Memorandum

TO: District of Columbia Zoning Commission

DATE: April 10, 2015

SUBJECT: **ZC 15-07 – Setdown Report** Consolidated PUD - 315 H Street NE
(Square 777, Lots 23-28 and 813-815).

Site Plan and Building Section (Pg. A5, A9)

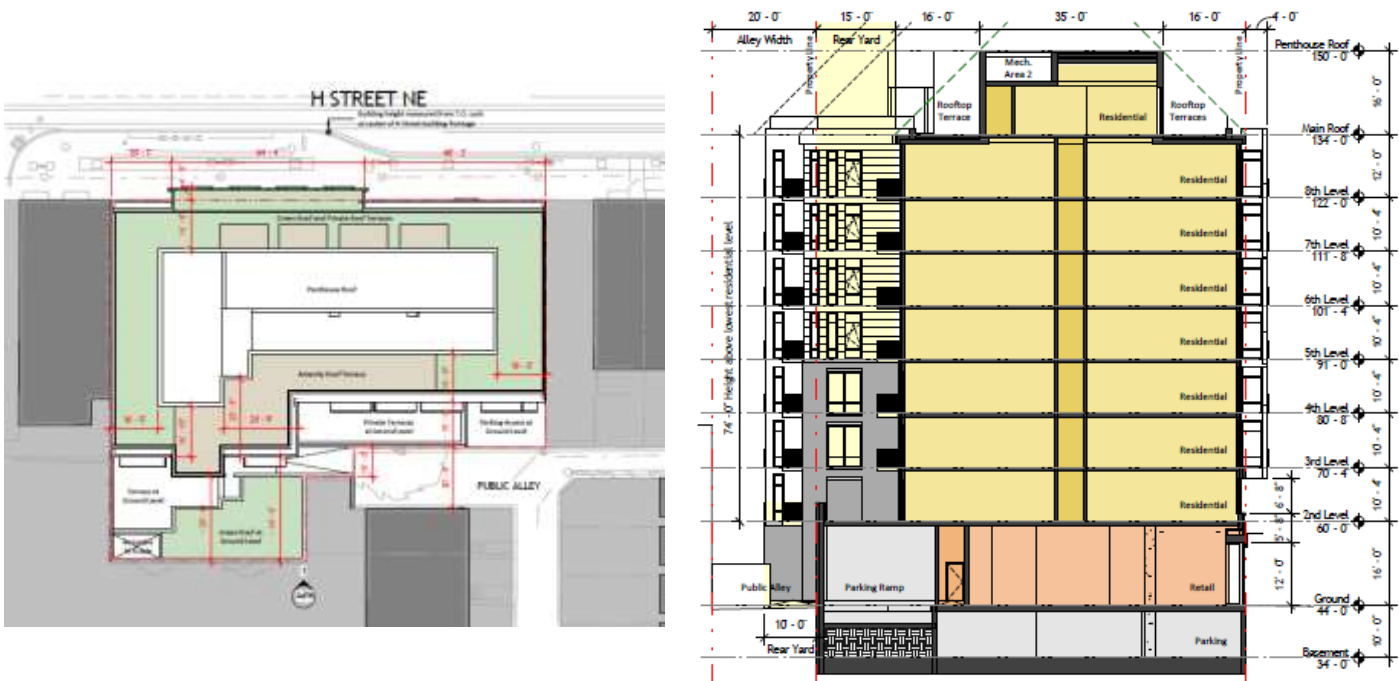
§ 1324 requires that buildings be constructed to the property line for the first 25' of height, in order to form a consistent street wall along the pedestrian realm. The Applicant requests flexibility to build the retail along the property line for 16' of height. At the first residential floor (2nd floor), a portion of the north façade projects beyond the property line a distance of 4'. The Applicant states they seek to distinguish the retail base from the residential tower. OP seeks additional explanation in this regard.

The proposed design does not provide the required 15-foot rear yard at the ground floor level measured from the centerline of the alley, but the requirement is satisfied at the upper floors, above 20', from the rear property boundary. Balconies are proposed within the rear yard. The loading and vehicular entry area would need to be redesigned to meet the rear yard requirement below 20'.

Projection signs shown on the section drawings (Plans- A9) are shown at 12 feet above the sidewalk with a projection that appears to meet the 3’-6” standard; however the Applicant should confirm it. OP anticipates that these requirements would be further reviewed when final plans are submitted, including at building permit review.

The proposed development effectively maximizes the irregular-shape of the site, as it satisfies most of the bulk and yard requirements under the PUD. More explanation is required with regard to the residential projection of 4’ beyond the public space boundary and the transition to the residential uses to the south. The development also provides for less than required on-site parking with a robust TDM, in recognition of the variety of transportation choices that is available at this location. More information is required with regard to the how the loading, in a public alley, will be managed in order to avoid conflicts with public alley uses and/or vehicles.
